Service Engineering Operations
Customer Service Division

**SUBJECT: NEW VEHICLE DEMONSTRATION / DELIVERY HOLD
Safety Recall 26S52**

Certain 2020-2027 Model Year Aviator and 2020-2026 Explorer Vehicles with Power Second-Row Seat – Second-Row Seat Easy Entry Switch Housing and Bezel Replacement

FIGURE 1

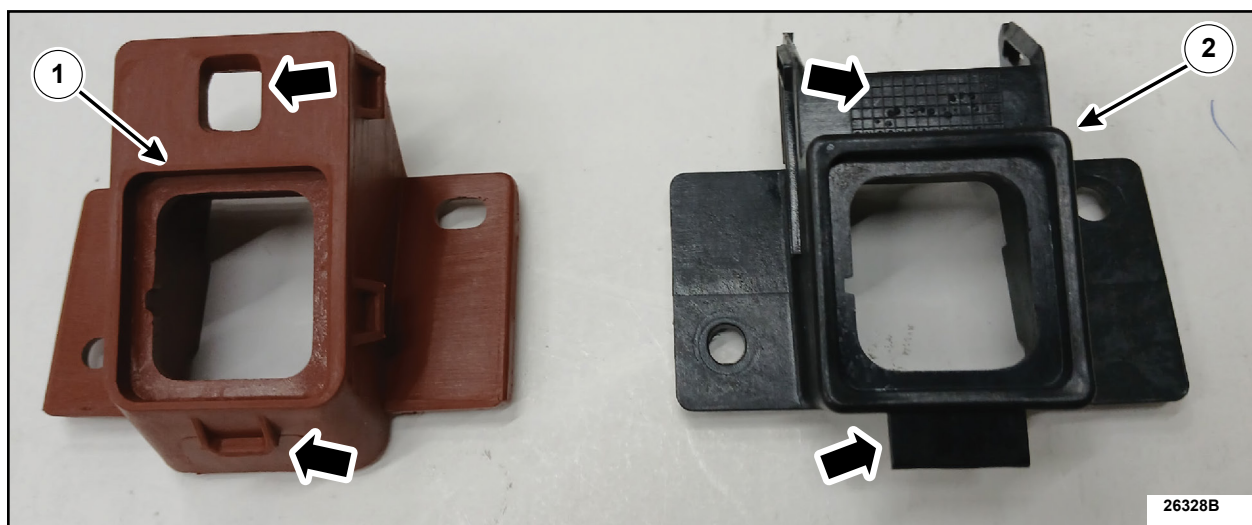
NOTE: The *new* components (1) are physically different than the original components (2) being removed in this procedure. See Figures 1 and 2 for the differences.
